Access Compliance Report

Public Rights-of-Way

(Pedestrian Signals)

Intersection ID: N/A	Main Street:	Cross Street: N/A	Location: N/A
ADA ID: 295E3071CFC0	Signal Type: One Push Button-Non APS	Overall Compliance: No	Severity Score: BTN 1: N/A BTN 2: N/A No BTN: N/A
Codes/Mitigation Info/Possible Solution		Field Measurements/Component Compliance

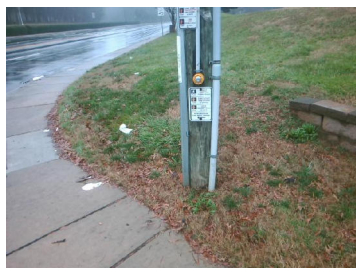
Possible Solutions: Replace Signal Push Button With APS Button on New Post. Remove & Relocate Sign.

PROW/ADA: TMUTCD 4e.08, R404.2, R404.7.3
